Well Name: OCHOA 8703 FEDERAL COM	Well Location: T23S / R28E / SEC 12 / SENE / 32.322569 / -104.033665	County or Parish/State: EDDY / NM
Well Number: 6H	Type of Well: OIL WELL	Allottee or Tribe Name:
Lease Number: NMNM103879	Unit or CA Name:	Unit or CA Number:
US Well Number: 3001549553	Operator: BTA OIL PRODUCERS LLC

Notice of Intent

Type of Submission: Notice of Intent	Type of Action: APD Change
Date Sundry Submitted: 04/08/2025	Time Sundry Submitted: 04:17
Date proposed operation will begin: 04/08/2025

**Procedure Description:** OCHOA 8703 FEDERAL COM 6H BTA Oil Producers, LLC respectfully requests the following footage, casing, cement, and drill plan changes to the original APD as approved. OCHOA 8703 FEDERAL COM 6H will now be an INFILL well to the OCHOA 8703 FEDERAL COM 9H (api #30-015-56288). OCHOA 8703 FEDERAL COM 9H will be the DEFINING well. Please see attached documents for more details. OLD FOOTAGES: SHL: 1787' FNL & 513' FEL (NO CHANGE) FTP: 2310' FNL & 330' FWL LTP: 2310' FNL & 2310' FWL BHL: 2310' FNL & 2600' FWL OLD FIELD & POOL: [98220] PURPLE SAGE; WOLFCAMP NEW FOOTAGES: KOP: 2260' FNL & 50' FWL FTP: 2260' FNL & 100' FWL LTP: 2260' FNL & 2571' FWL BHL: 2260' FN

## ACREAGE DEDICATION PLATS

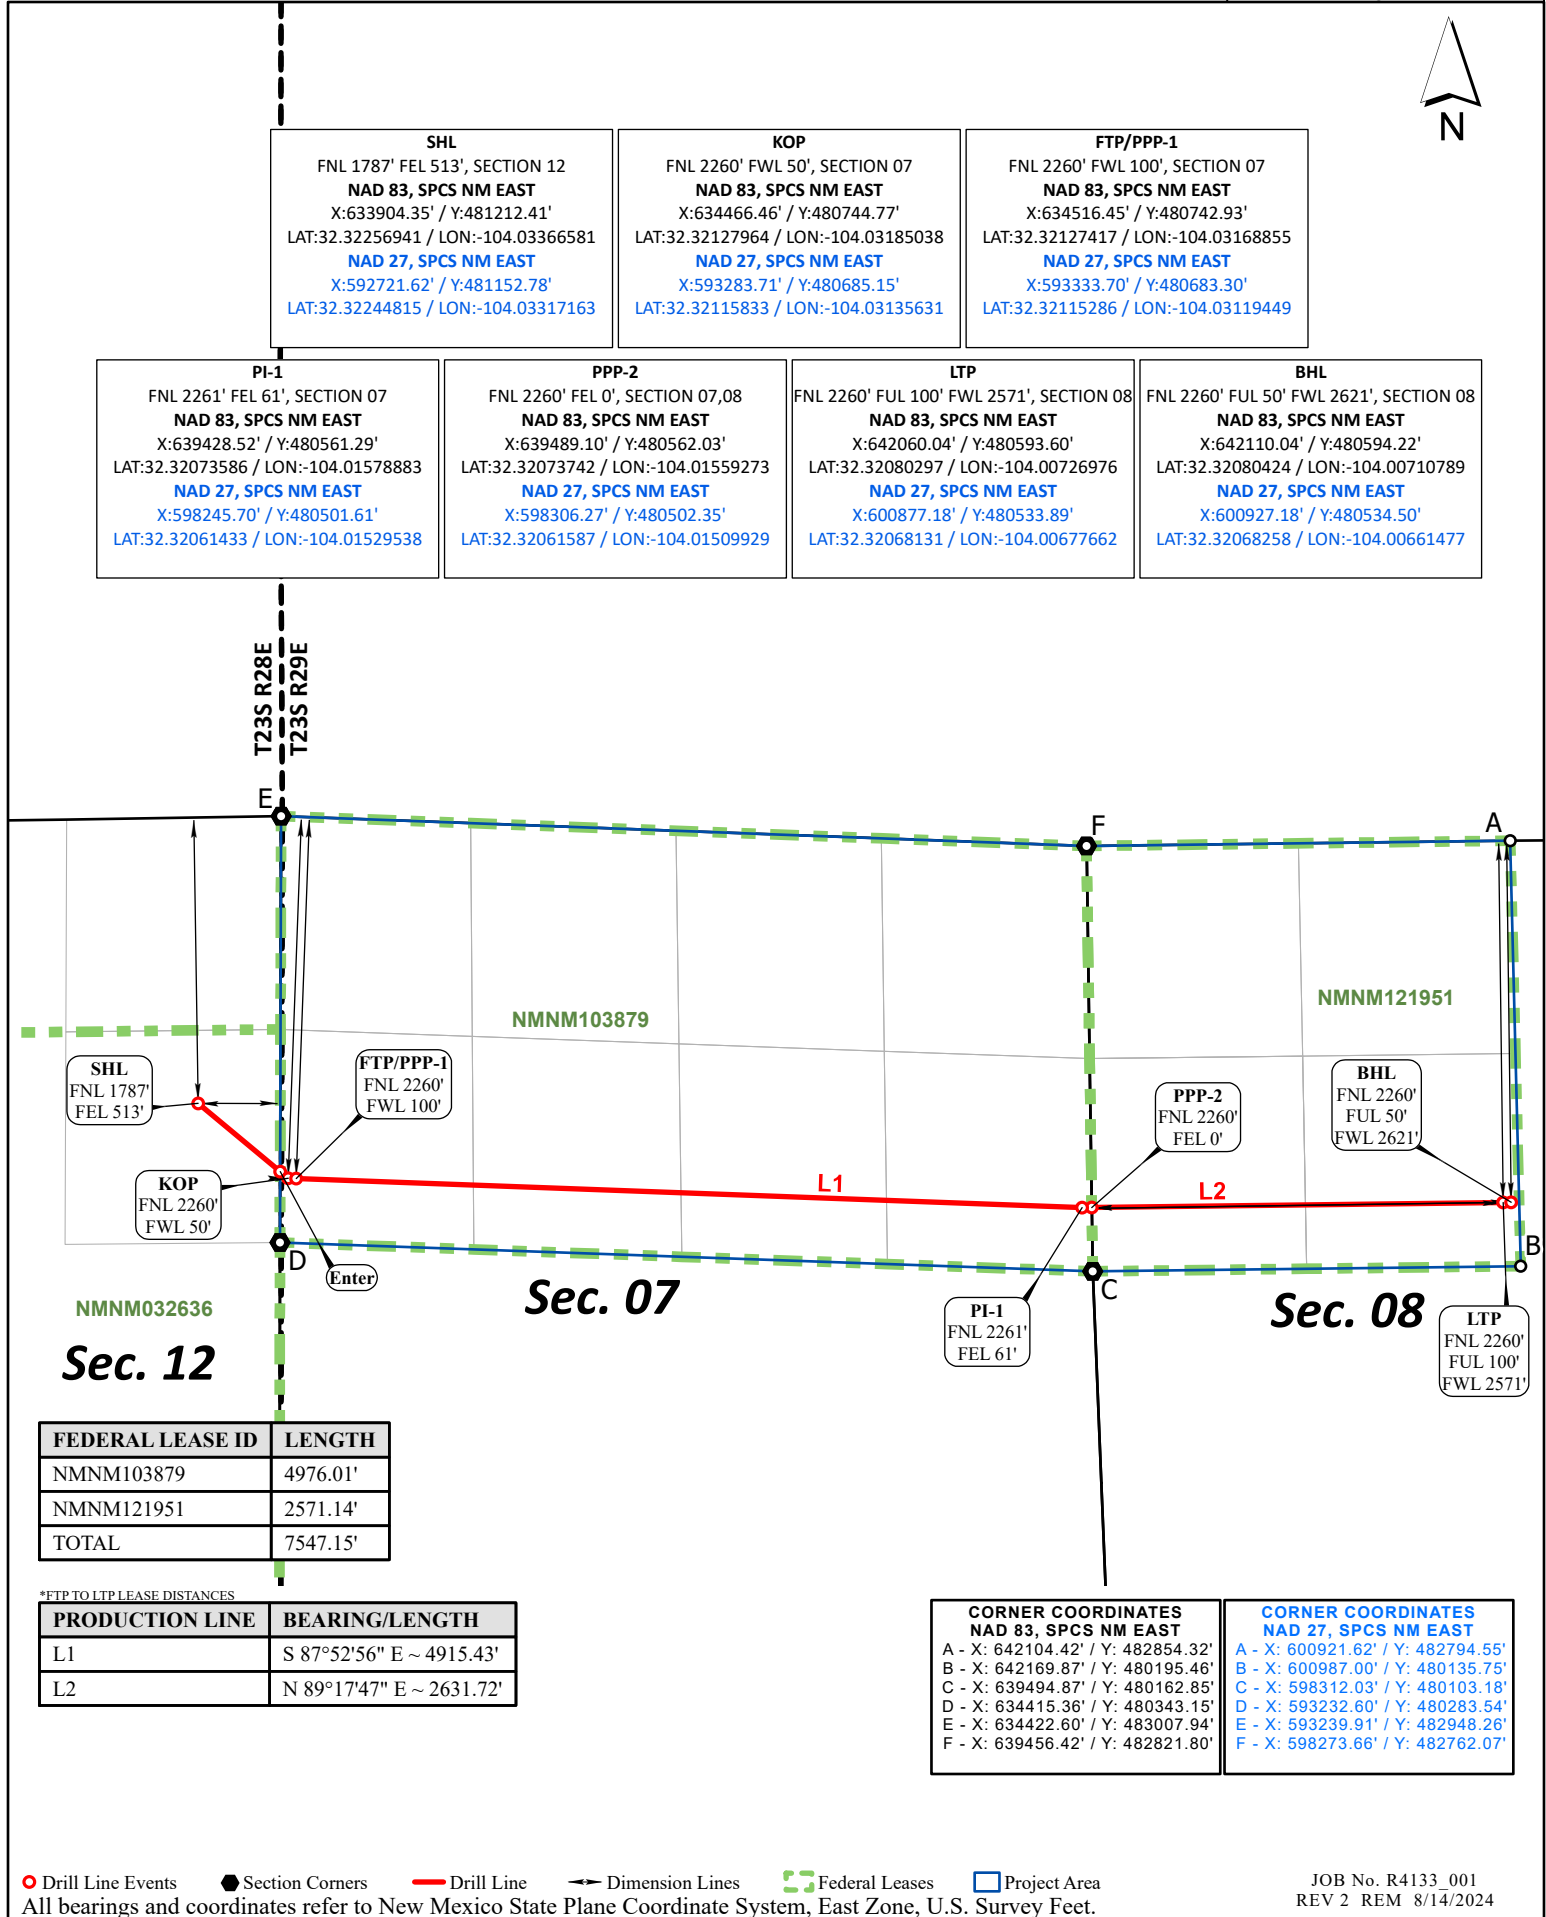
<b>C-102</b>  Submit Electronically Via OCD Permitting	<b>State of New Mexico</b> <b>Energy, Minerals, &amp; Natural Resources Department</b> <b>OIL CONSERVATION DIVISION</b>		Revised July 9, 2024
	Submittal Type:	<input type="checkbox"/> Initial Submittal	
		<input checked="" type="checkbox"/> Amended Report	
		<input type="checkbox"/> As Drilled

UL F	Section 8	Township 23S	Range 29E	Lot	Ft. from N/S 2260' FNL	Ft. from E/W 2621' FWL	Latitude 32.32080424	Longitude -104.00710789	County EDDY
---------	--------------	-----------------	--------------	-----	---------------------------	---------------------------	-------------------------	----------------------------	----------------

UL E	Section 7	Township 23S	Range 29E	Lot L 2	Ft. from N/S 2260' FNL	Ft. from E/W 50' FWL	Latitude 32.32127964	Longitude -104.03185038	County EDDY
---------	--------------	-----------------	--------------	------------	---------------------------	-------------------------	-------------------------	----------------------------	----------------

UL E	Section 7	Township 23S	Range 29E	Lot L 2	Ft. from N/S 2260' FNL	Ft. from E/W 100' FWL	Latitude 32.32127417	Longitude -104.03168855	County EDDY
---------	--------------	-----------------	--------------	------------	---------------------------	--------------------------	-------------------------	----------------------------	----------------

UL F	Section 8	Township 23S	Range 29E	Lot	Ft. from N/S 2260' FNL	Ft. from E/W 2571' FWL	Latitude 32.32080297	Longitude -104.00726976	County EDDY
---------	--------------	-----------------	--------------	-----	---------------------------	---------------------------	-------------------------	----------------------------	----------------
